D1000407 aLIGO\_OSUMS\_INTERMEDIATE\_SUPPORT\_RIGHT\_SIDE\_BRACKET, PART PDM REV: X-010, DRAWING PDM REV: X-011

REV.	DATE	DCN #	DRAWING TREE #
v1	JUN-29-2010	E1000234	
<b>v2</b>	<b>29 MAR 2011</b>	<b>E1100277-V1</b>

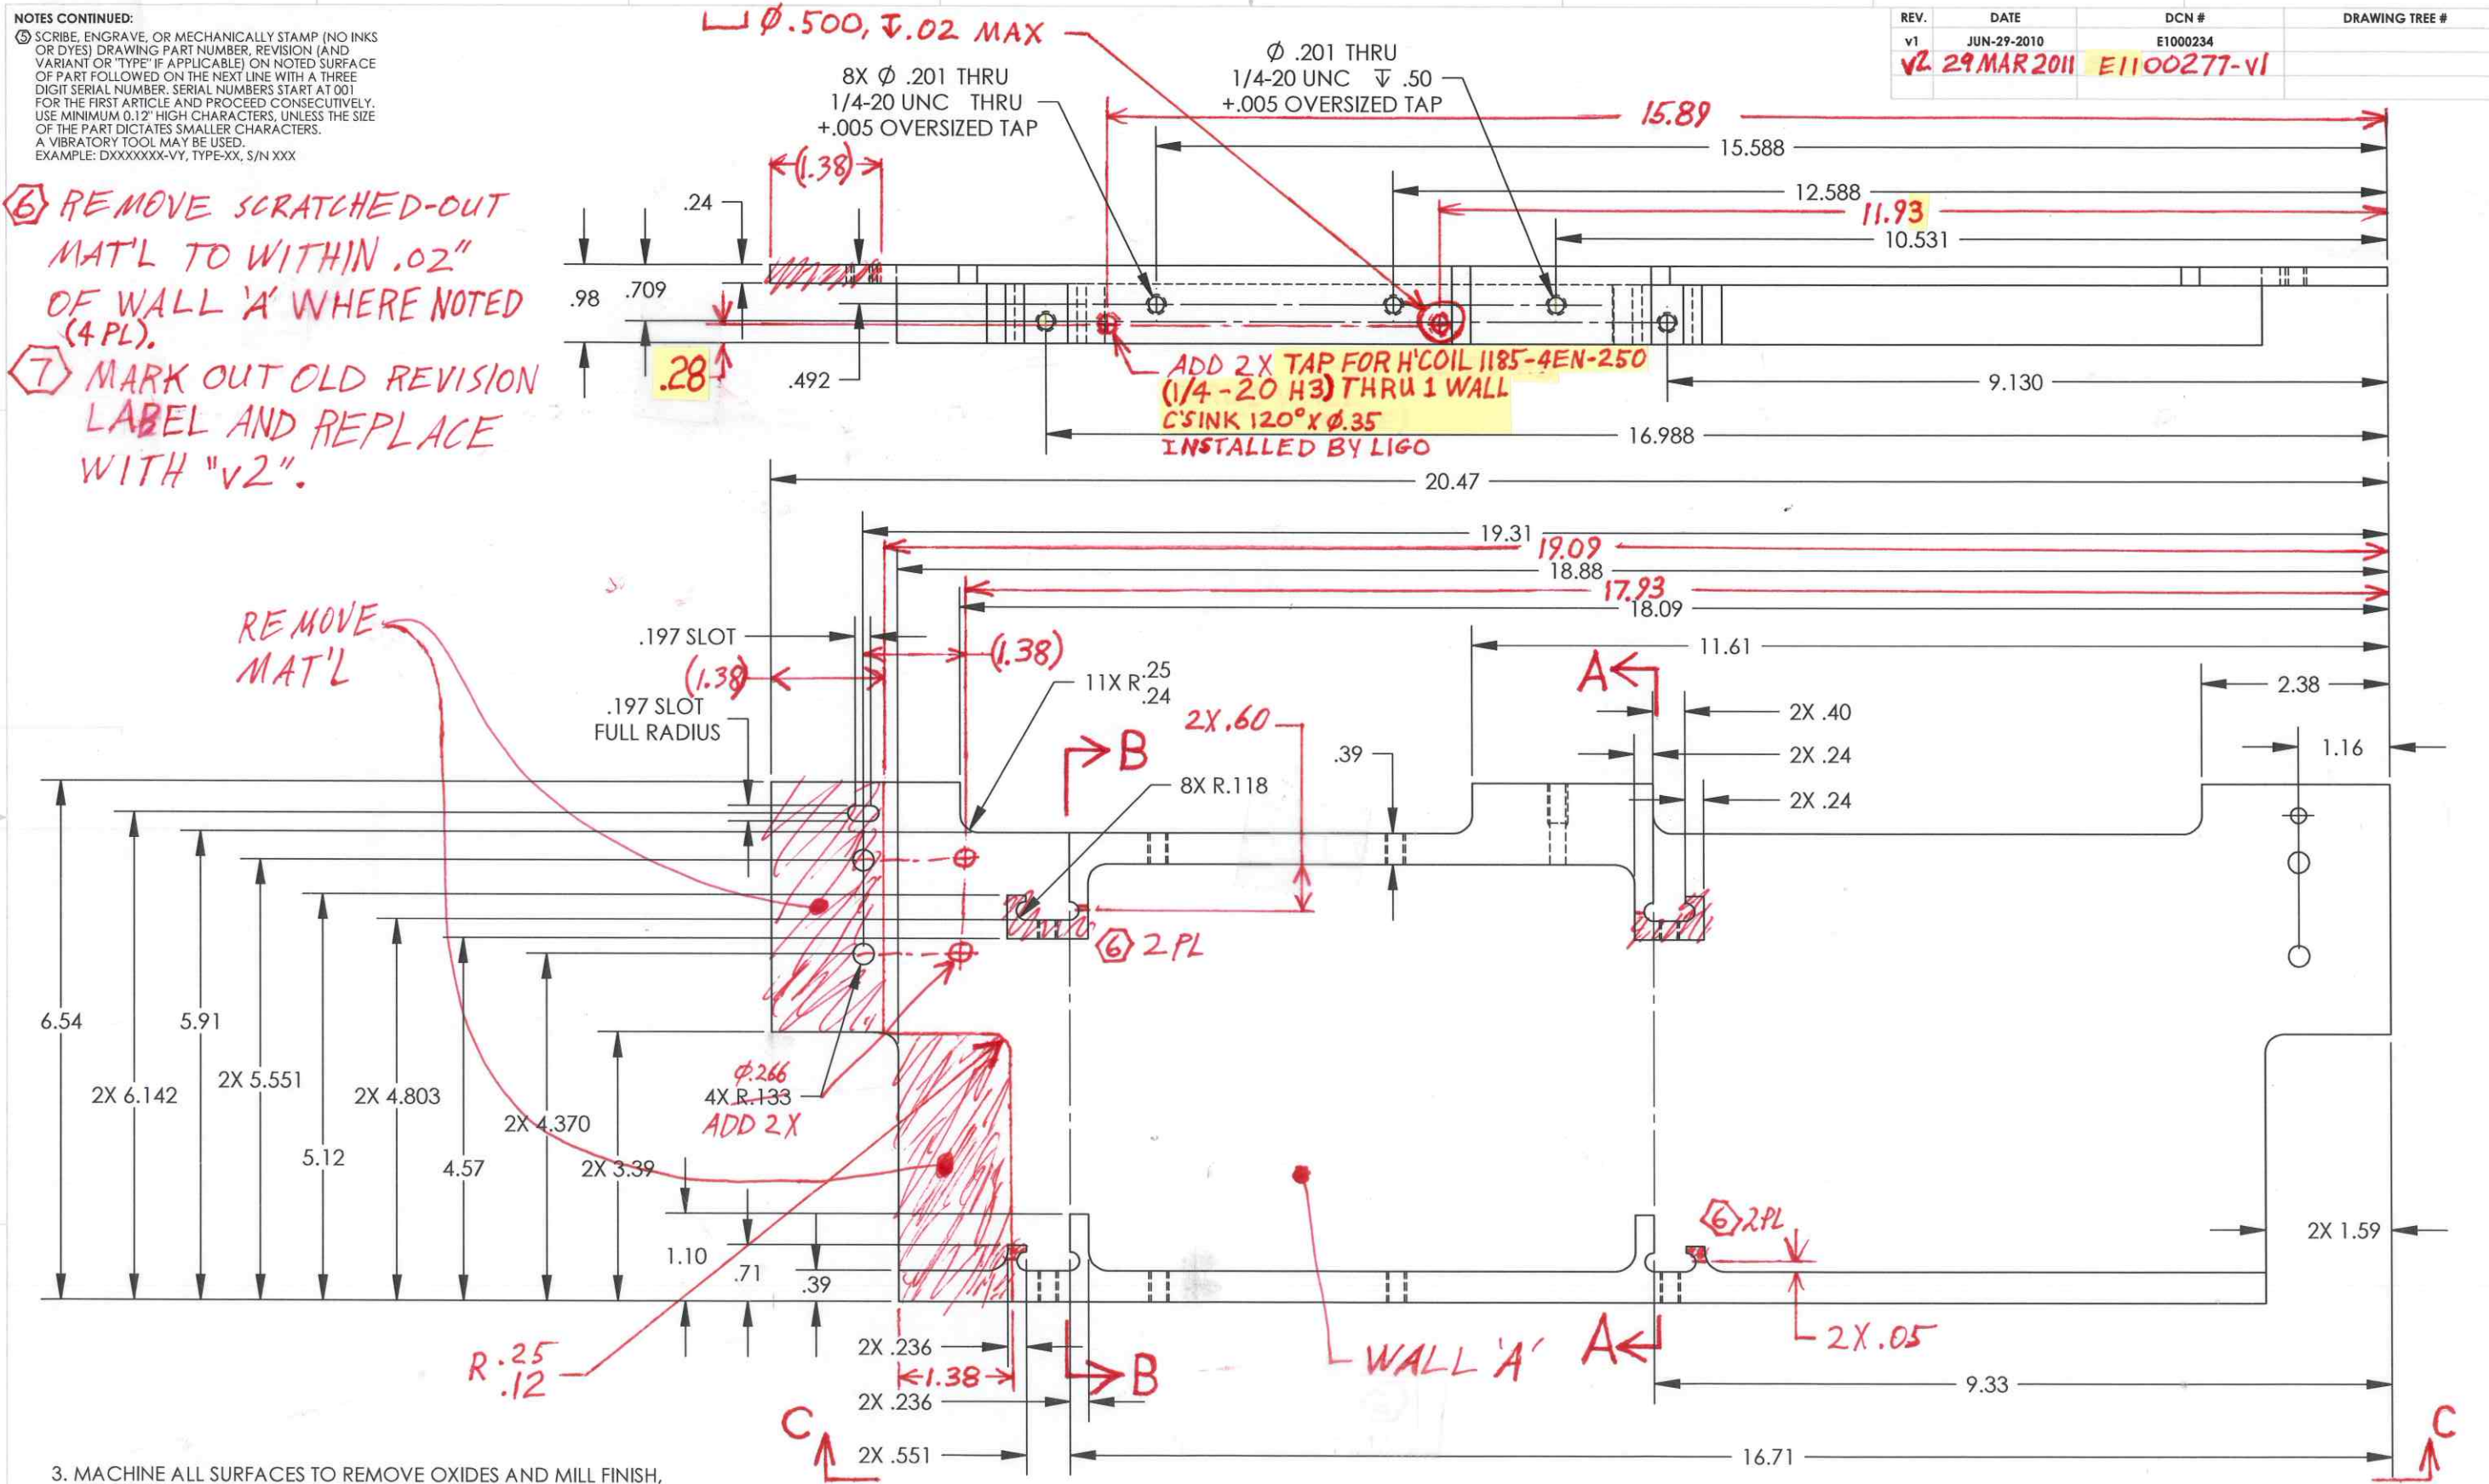
6 REMOVE SCRATCHED-OUT MAT'L TO WITHIN .02" OF WALL 'A' WHERE NOTED (4 PL).

7 MARK OUT OLD REVISION LABEL AND REPLACE WITH "v2".

VIEW A-A (ENLARGED)  
VIEW B-B OPPOSITE  
(SHOWN AFTER MATERIAL REMOVAL)

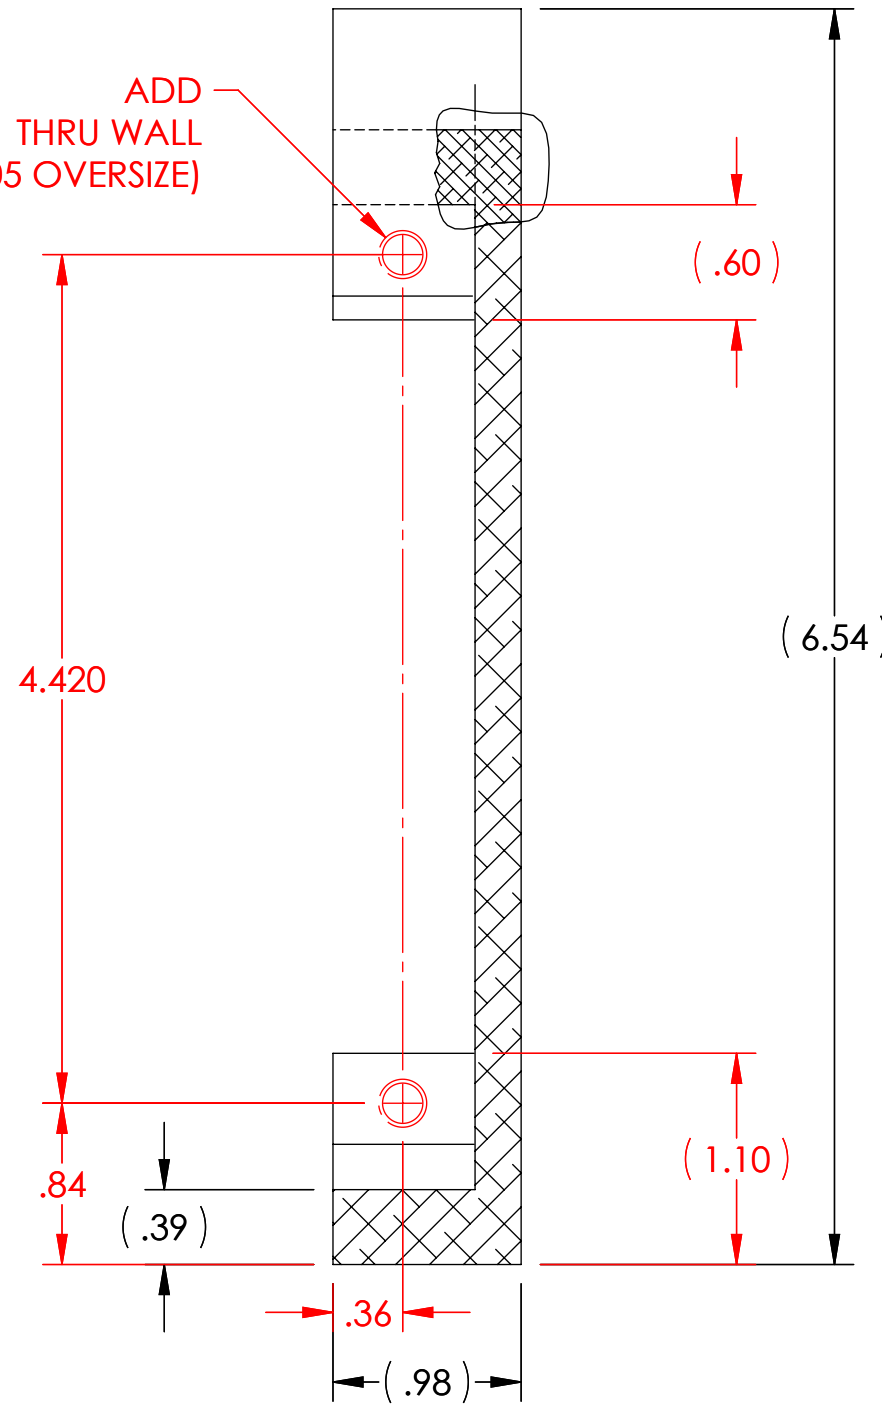
ADD  
2X 1/4-20 UNC-2B H11 THRU WALL  
(.005 OVERSIZE)
